ENGINE INDICATING - REPLACE THE EGT HARNESS CLAMP BOLTS AT FLANGE FP - CATEGORY CODE 6
- MOD.ENG-77-0006

- (1) Aircraft: Airbus A320
- (2) Engine: V2500-A1 Engines before Serial No.V0122.

V2500-ENG-77-0006

Location of EGT harness clamp bolts
Fig.1 Sheet 1 of 2

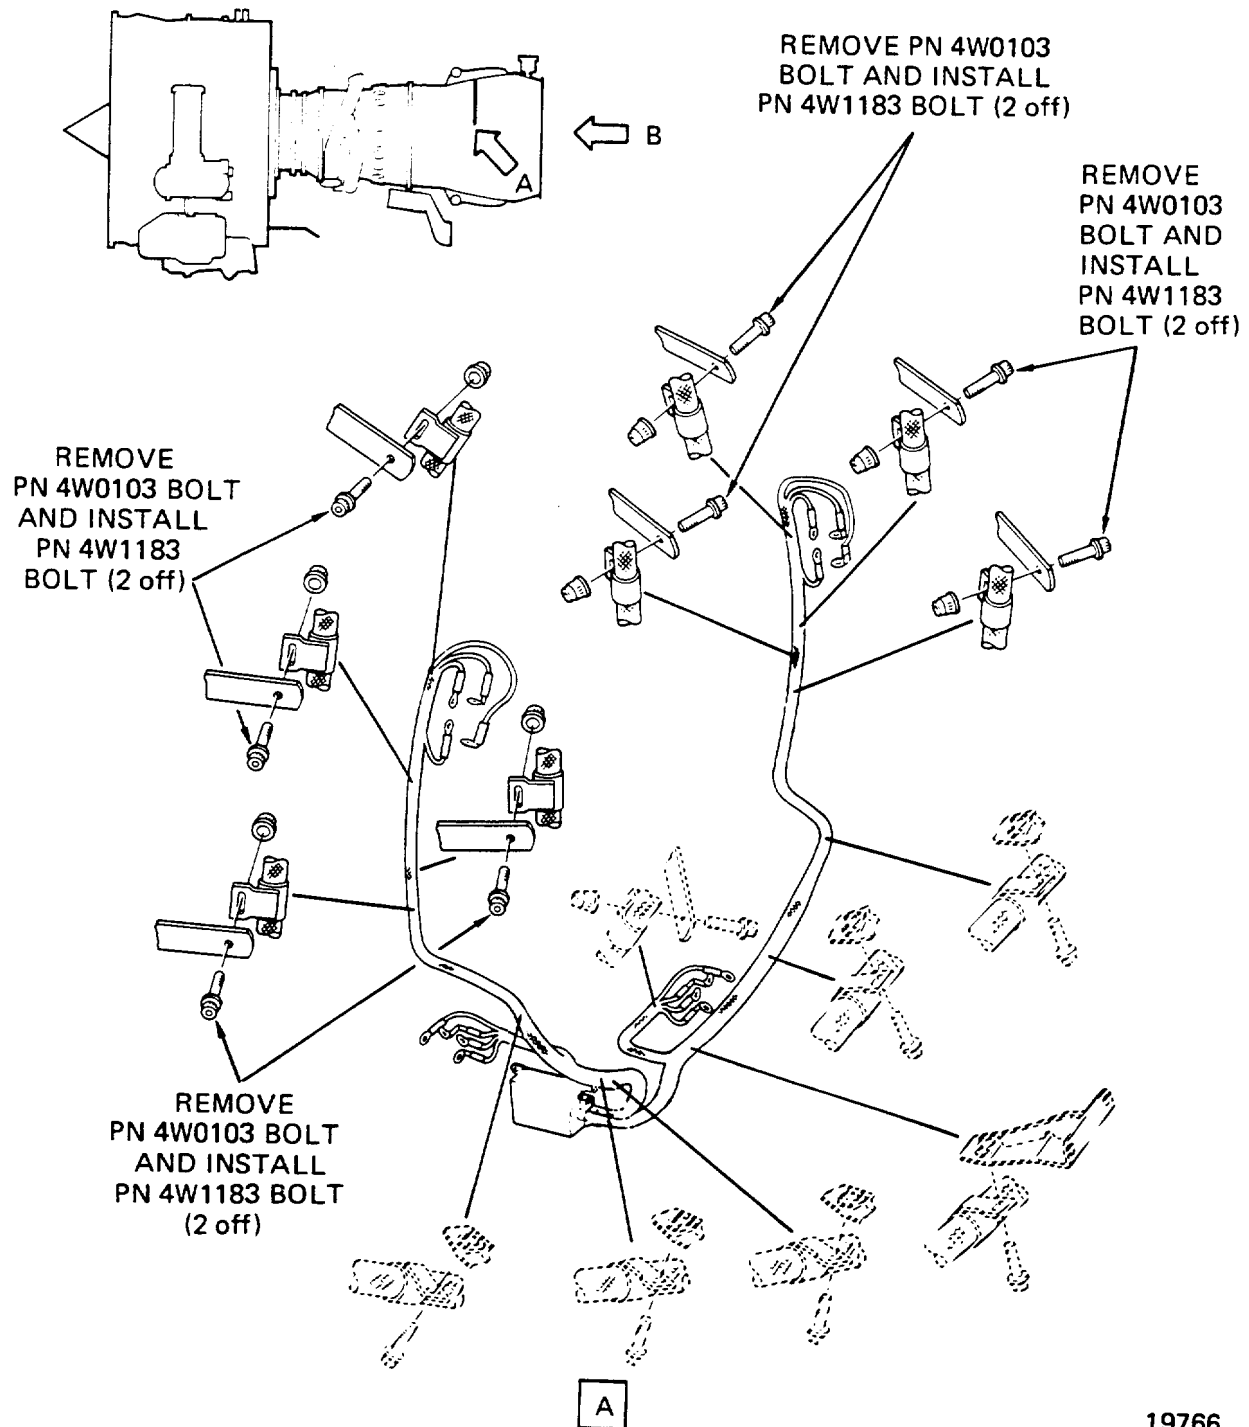
There can be interference between the double hexagon head bolts at clipping points 6000 and 6013 and the nacelle rear cowl doors. This is caused by tolerance stack-up and positioning of brackets, bolts, and nacelle parts.

To provide additional clearance between the Exhaust Gas Thermocouple (EGT) Mounting Bolt Heads located on flange "FP" Brackets (Clipping Points 6000, 6001, 6002, 6003, 6010, 6011, 6012 and 6013) and the heat shielding and local pans at the cowl load sharing bumpers of the nacelle.

- (1) Low profile Hexagon Head Bolts eliminate the interference with the nacelle parts.

- (1) Install the EGT Harness Assembly by the approved procedure in Reference (1) Chapter/Section 72-00-50, Installation -07, and Figure 1 except:
 - (a) Replace 4W0103 Bolts with 4W1183 Bolts at Clipping point 6000, 6001, 6002, 6003, 6010, 6011, 6012 and 6013.
